Bulletin No.: 12-03-08-001

Date: August 06, 2012

Subject: Clunk or Thump Type Noise from Front Suspension

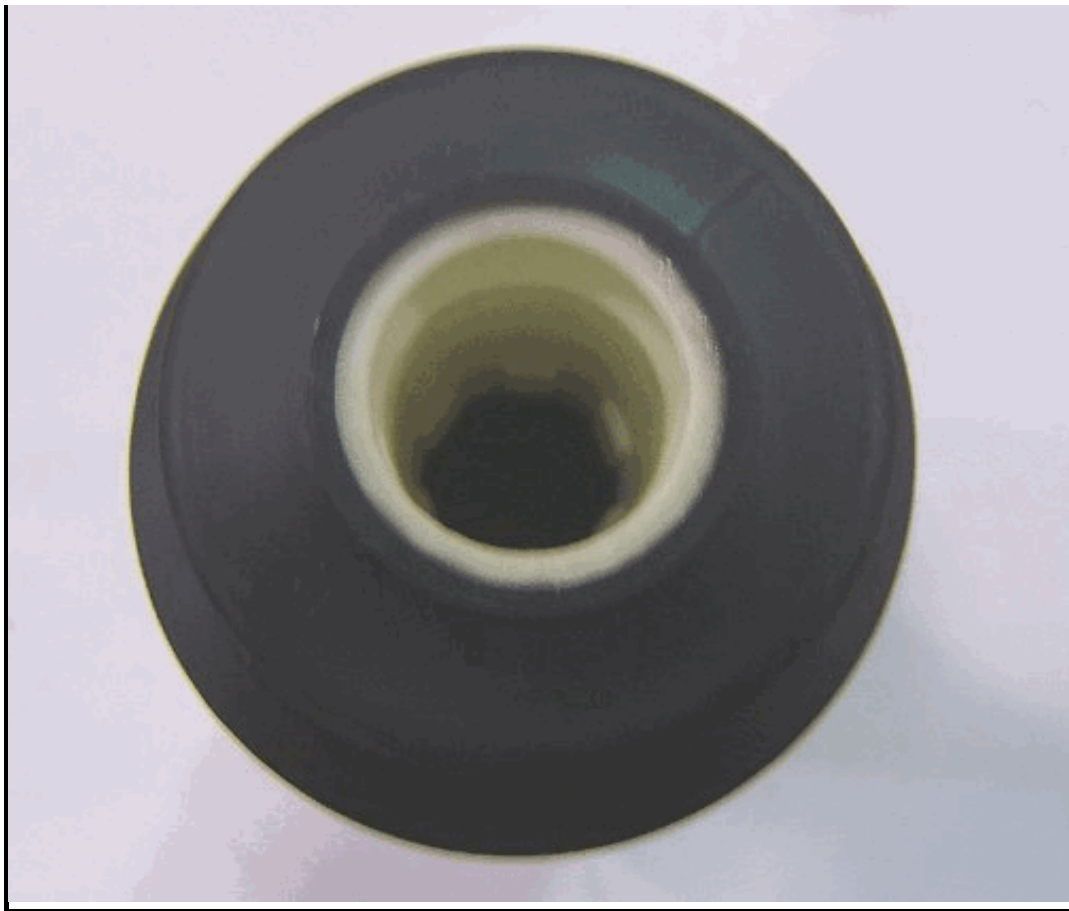
This condition may be caused by the jounce bumper slamming into the upper spring seat because it is not retained in the correct up position. The jounce bumper loses position due to oil being deposited onto its retention fingers. The oil is from the strut leaking.

Inspect the front strut(s) for evidence of oil. The leak may be slight but will still cause the concern. If oil is present, replace the affected strut, jounce bumper and dust boot (shield). Before reassembling the strut assembly, glue the new jounce bumper and new dust boot (shield) to the upper spring seat using the steps listed below. To further confirm this concern, the shield/bumper will easily slide up and down the strut shaft.

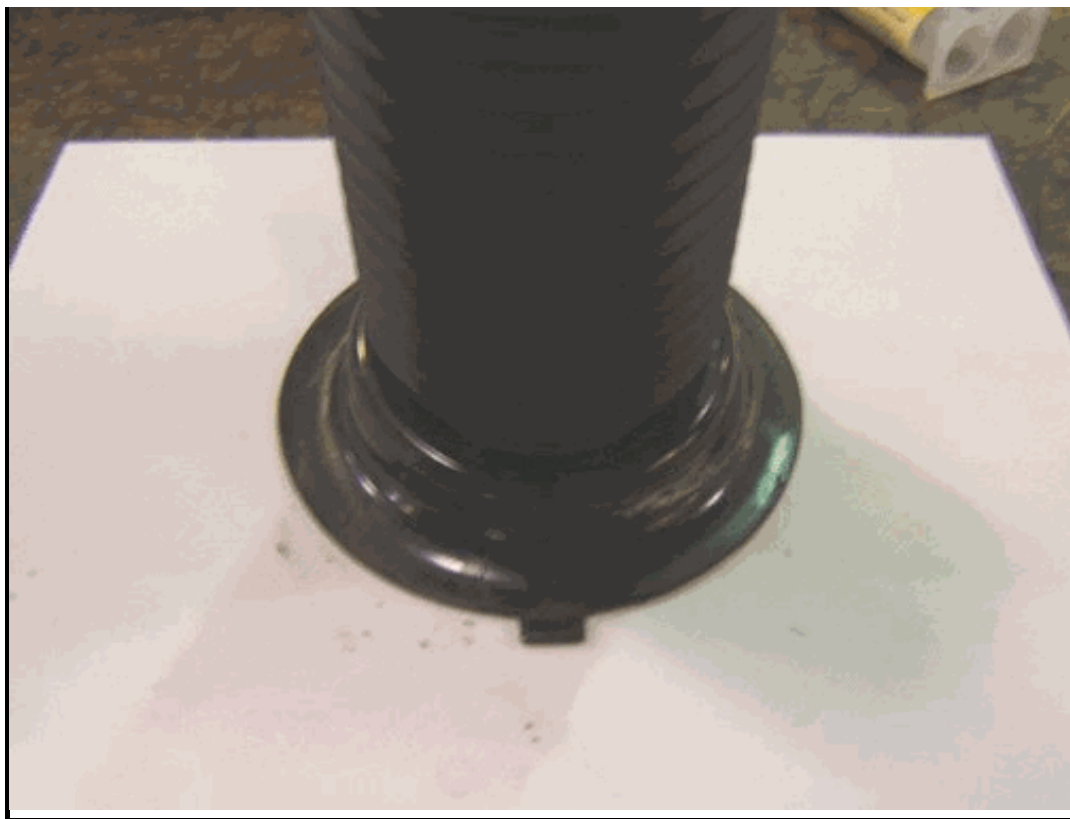
3. Glue the bumper to the inside of the dust boot (shield) as shown. Use \*3M(TM) Duramix(TM) Super Fast Adhesive, P/N 04747 or equivalent. Allow to cure thoroughly 5-10 minutes at room temperature.

4. Apply a light coat of \*3M(TM) Automotive Adhesion Promoter, P/N 06396 or equivalent, to the top of the dust boot (shield) and to the upper spring seat surface. Allow to dry 10 minutes.

5. Glue the dust boot (shield) to the upper spring seat as shown using the above recommended adhesive. Allow to cure thoroughly.
